KAISER ENGINEERS HANFORD

W-105-124

W-105, RESPONSE TO LOI 73

SUBJECT: Technical Response to Westinghouse Letter August 28, 1991; Regarding W-105 Project and WDOE Inquiries Regarding Same

Figure 2

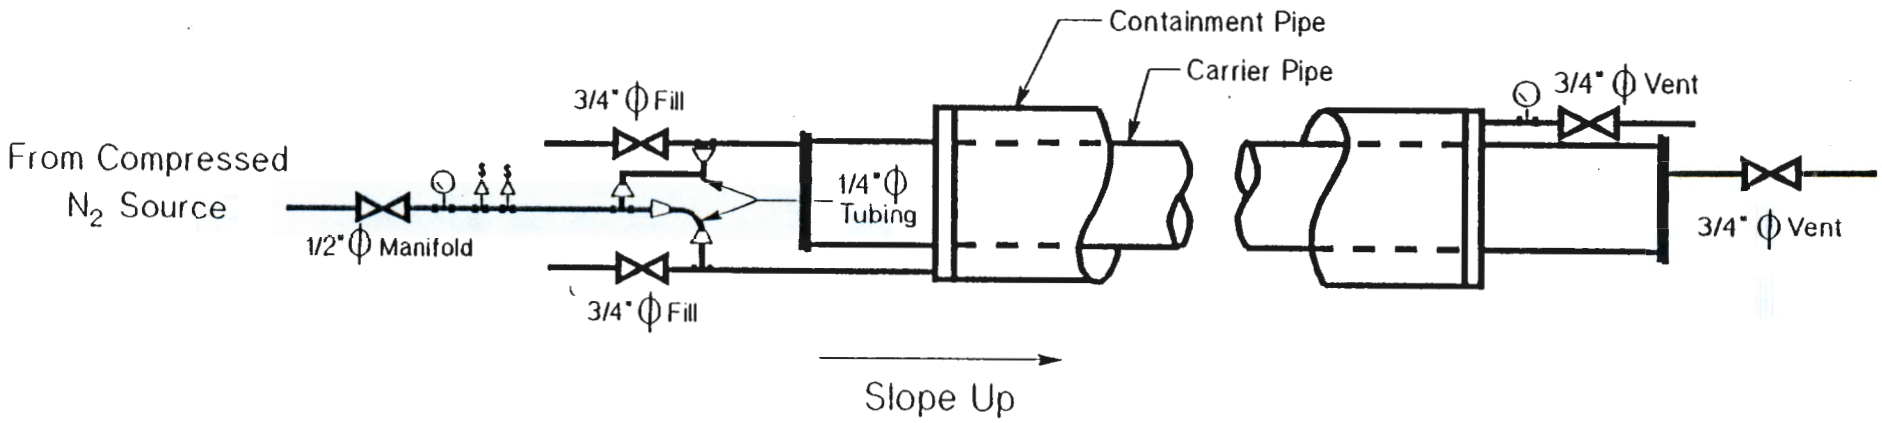
The carrier pipe and the containment pipe are required to pass separate hydrostatic tests. The carrier pipe is tested at 150 lbf/in^2 (gauge) and the containment pipe at 90 lbf/in^2 (gauge) (see Figure 2). The subject failures occurred in the 8-inch carrier pipes at some point during the hydrostatic testing operations (filling, venting, pressurizing and depressurizing) for the 12-inch containment pipe, following successful hydrostatic testing of the 8-inch carrier pipe (see Figures 3 through 6).

The pipefitter crews devised and set up the hydrostatic test rig (see Figure 2) to meet the general requirements of the applicable construction specification, W-105-C3, and Book 2 of the KEH Construction Force Manual, Procedure CFM 6.1 for hydrostatic tests. The crews also developed their own methods for filling, pressurizing, venting, and depressurizing the piping for the hydrostatic test operations. No engineering sketch or drawing of the specific test arrangement was available. Valve opening and closing sequences were carried out according to past experience and best judgement. This is apparently consistent with construction force practices at Hanford for hydrostatic testing of piping systems. However, most piping applications are of single wall design and prior to the use of fiberglass reinforced pipe, applications of double contained piping at Hanford involved carbon steel and stainless steel piping which are significantly less susceptible to failure from external pressure.

The hydrostatic test rig (see Figure 2) relied on 1/4-inch tubing connected between the carrier and the containment pipes to maintain an equal pressure between the two at all times during filling, pressurizing and venting. Two gauges were used during hydrostatic tests. One gauge was installed at the fill end and one at the vent end on the containment pipe for pressure testing of the 12-inch containment pipe. The gauge at the fill end was assumed to indicate at all times the pressure in both the 12-inch containment pipe and the 8-inch carrier pipe.

Improved field engineering support should be provided to the pipefitters, particularly when new technology is involved as in the case of double containment fiberglass pipe. Consideration should be given to development of a modified test rig for double containment fiberglass pipe that would preclude excessive external pressure on the carrier pipe during hydrostatic testing of the containment pipe.

Figure 4. Failed Section of 8-Inch Carrier Pipe from LERF Basin 42-43

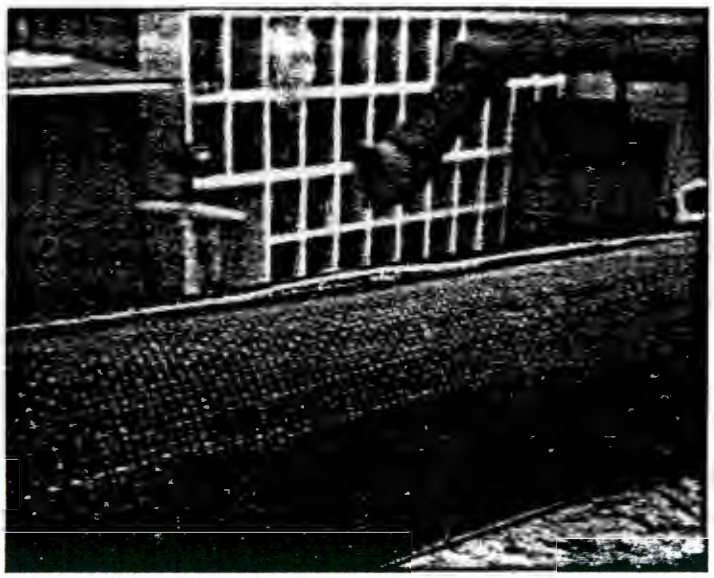
and was several inches longer on the inside than on the outside. The fracture extended between two carrier guides but had arrested short of passing through either guide. The fracture from the Basins 42-43 carrier pipe measured approximately 4 feet 5 inches, also being slightly longer on the inside. The fracture extended between a guide and bell type socket joint. The fracture extended to the end of the pipe but did not extend beyond the joint to the bell end section. The joint was separated when observed in the shop (see figure 6). The opposite end of the fracture arrested short of passing through the guide. The exterior fracture appearance was essentially unbranched and identical for both pipe sections. Both interior fractures exhibited branching and areas of delamination of the pure resin layer from the glass reinforced resin outer layer.

Figure 6. Failed Section of 8-Inch Carrier Pipe from LERF Basin 43-44, Bell Type Coupling

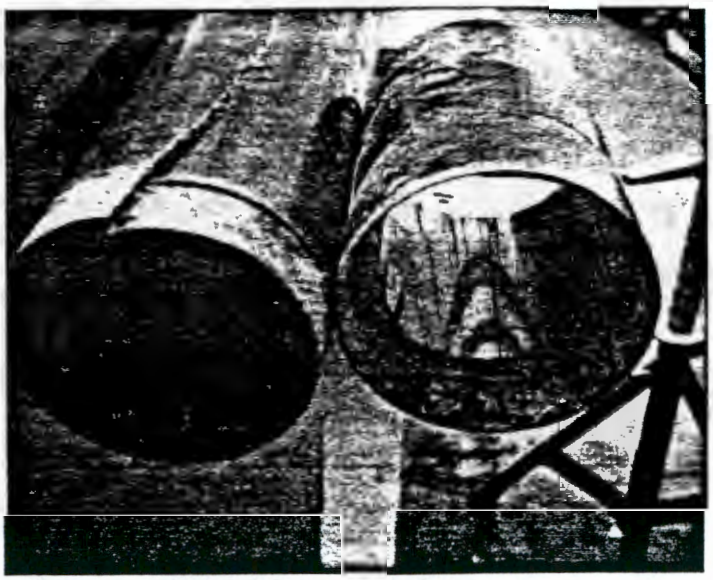
Information provided from a Fibercast engineer present for removal of the failed carrier pipe at Basins 42-43 indicated that the bell type coupling joint (see Figure 6) was still together (pipe end in bell) prior to removal of the failed section. However, the bonded joint had peeled completely around except at one small location near the top where the bond was still intact. The removal operation broke the remaining bond area and the joint separated. The fact that some bonded area remained intact suggests that the pipe end was forced radially inward by the pressure in the containment pipe.
